DESIGN REVIEW COMMITTEE

June 20, 2024 6:00 PM

AGENDA

DEPARTMENT OF PLANNING AND ZONING
PLANNER'S REPORT

PROPOSED FRONT ELEVATION

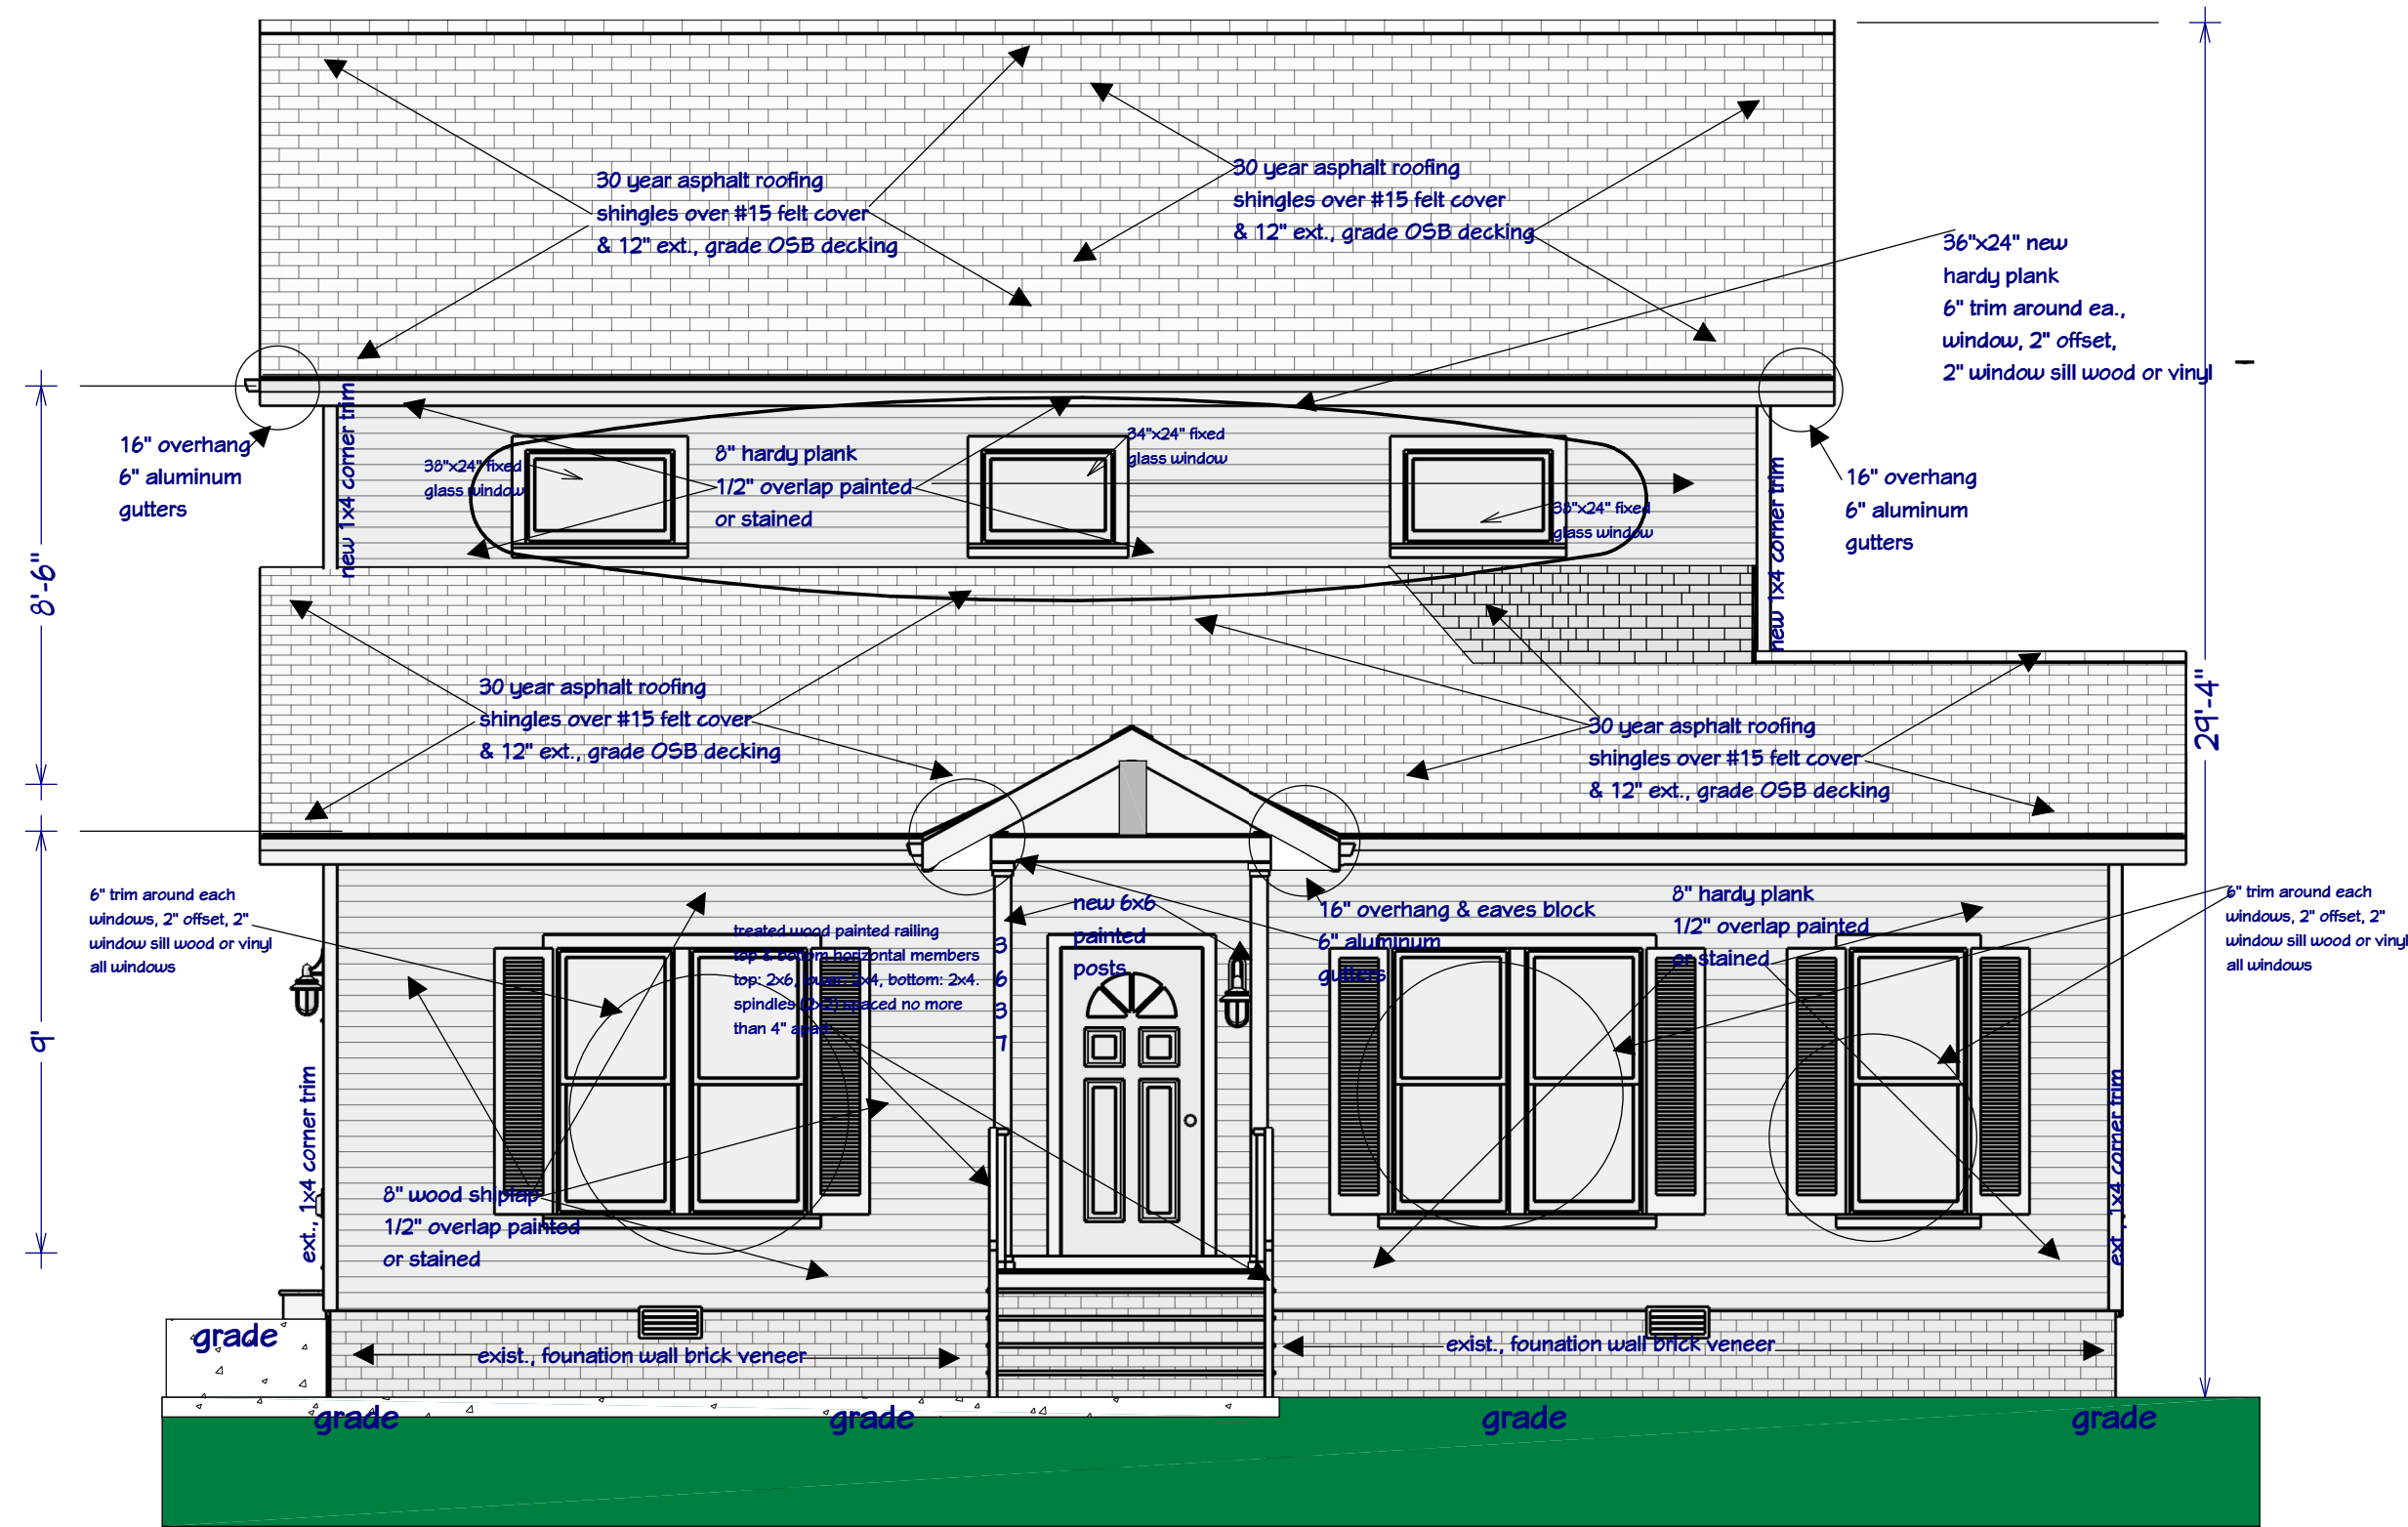
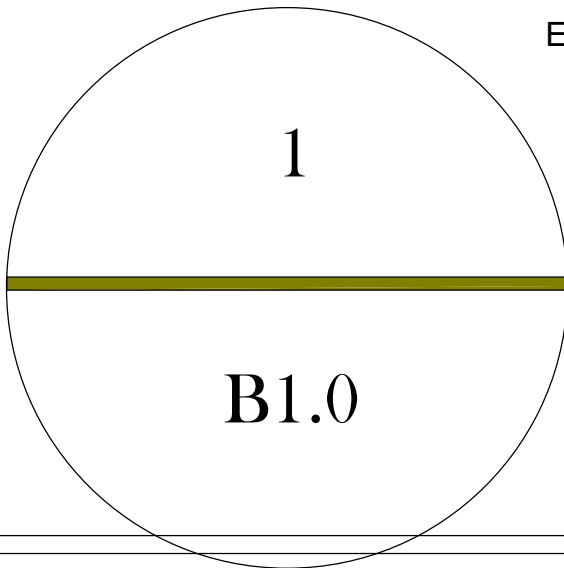
- The slope on the front porch gable is not the same slope as constructed (proposed front elevation). This should be corrected.
- The window sizes on the front second floor plans do not match the new windows as installed (Item #4 in Applicant letter, proposed floor plan-2nd floor). This should be corrected.

- The soffits are now shown with eaves blocks (item #6 of Applicant letter) **instead** of sloped soffits as required from the meeting and as shown and approved from previous submissions (all elevations). The DRC directed the applicant to keep the sloped soffits and correct during construction when application revisions are approved.

- A 2" sill (wood, hardy-plank or vinyl) has been called out on the proposed front elevation drawings and in Item #3 of the applicant letter. It is recommended that the DRC see the proposed sill material/design detail.

PROPOSED RIGHT SIDE ELEVATION

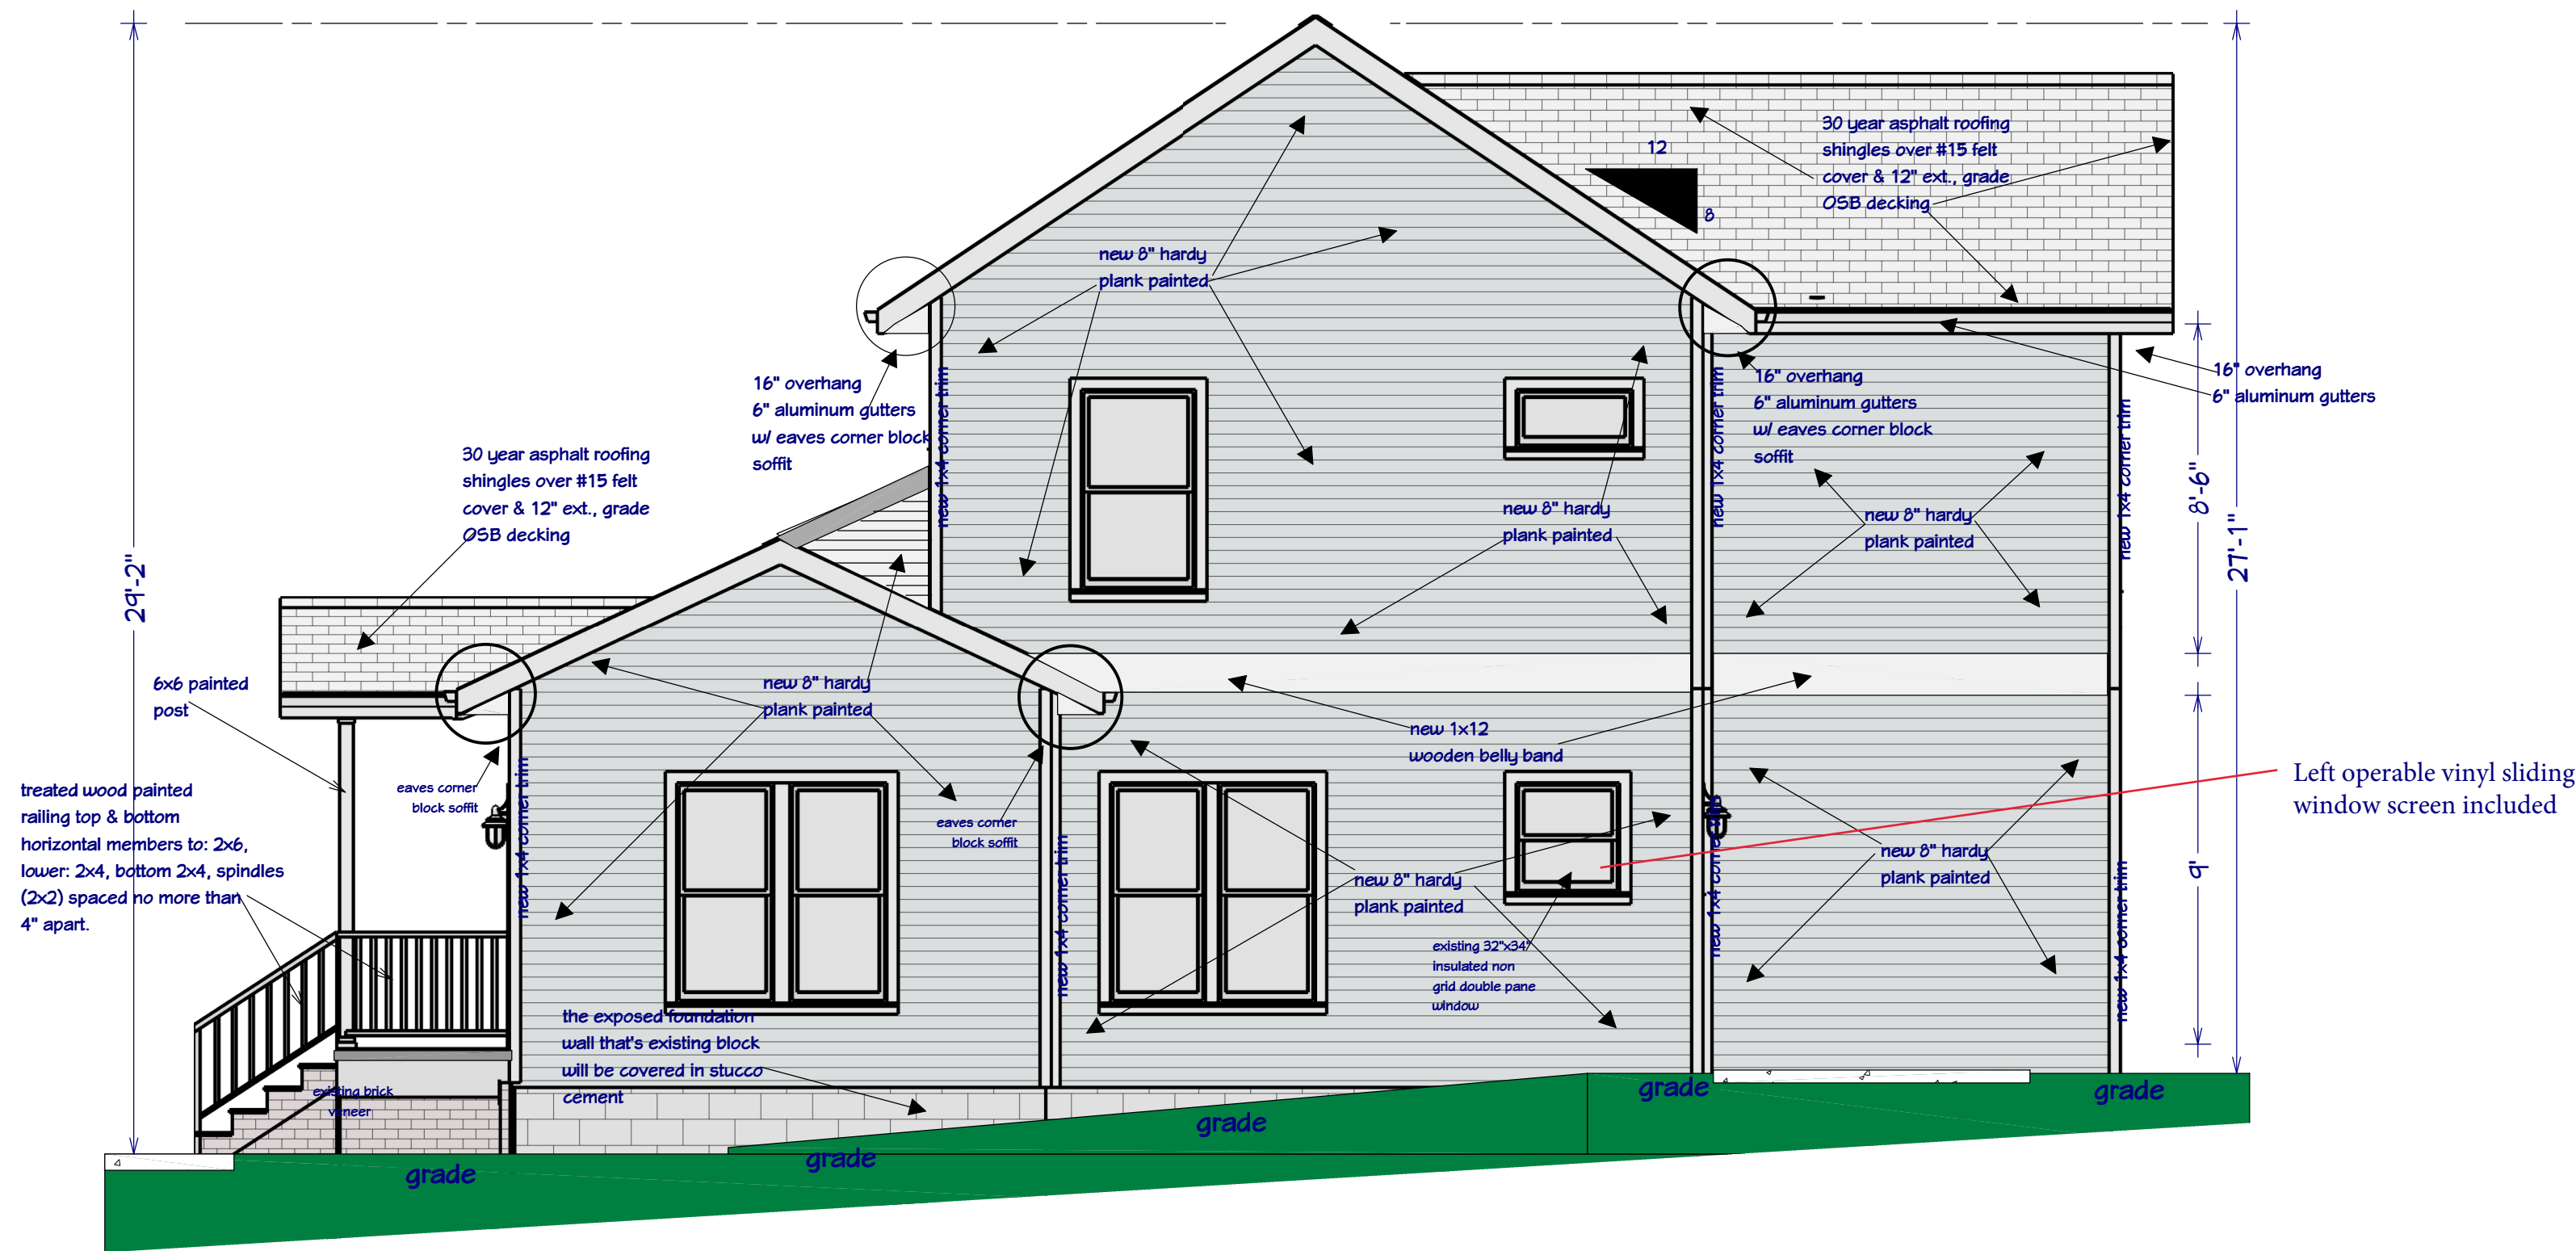
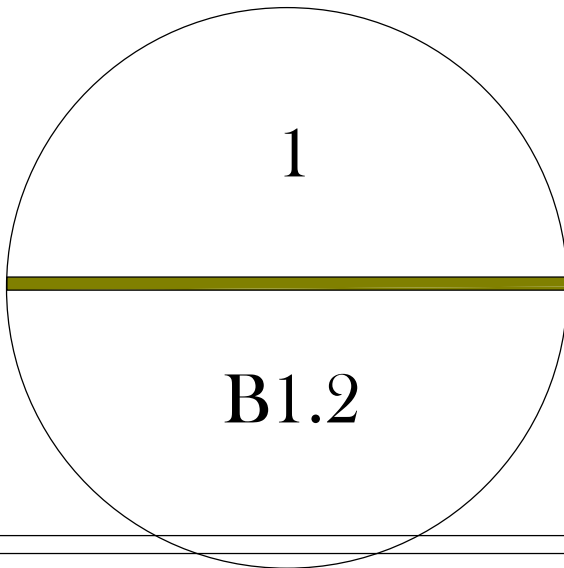
- A 12” overhang is still shown on the Proposed Left Side Elevation though a 16” overhang is requested and shown on the other 3 elevations.
- The proposed right-side and left-side elevations still show fixed transom windows, yet the installed windows are described as operational (Item #5 indicated in the letter dated June 10, 2024).
